**Subject:** CPU Public Comments

RE: City of San Diego – Public Review Draft Clairemont Community Plan, dated May 2021

RE: Clairemont Community Plan Update

**Draft CPU, Section 5.1, Public Facilities, Services & Safety**

(2020)

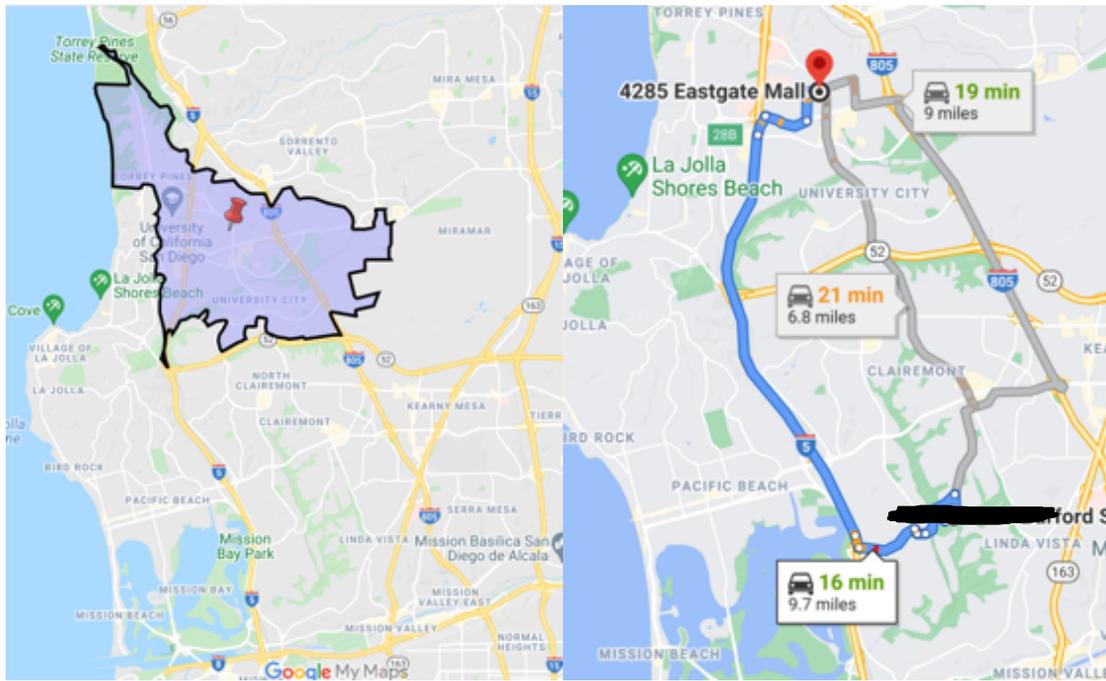
**C. The City’s General Plan PF-D.5. specifically states stations should be reassessed at time of Community Plan Updates AND/OR when such stations are attending more the 2,500 calls/year.**

**Both currently apply to the Clairemont plan area and specifically Station 36.**

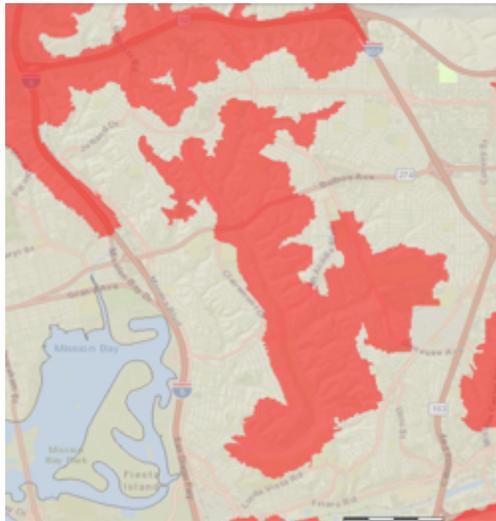
**E. Almost 1/3 of Clairemont’s 13+ sq. miles are WUI (Wildland-Urban Interface) and requires special consideration for fire services, especially with increasing density.**

- Areas where open space intersect with development is called a Wildland-Urban Interface or WUI.

*A WUI is defined by the State as: “a zone of transition between unoccupied land and human development.” Or anywhere that urban development meets “undeveloped wildland or vegetative fuels”, like Clairemont’s canyons.*

- Clairemont is riddled with WUI land, where our neighborhoods border dry brush and steep hillsides. There are specific building code requirements for WUIs.
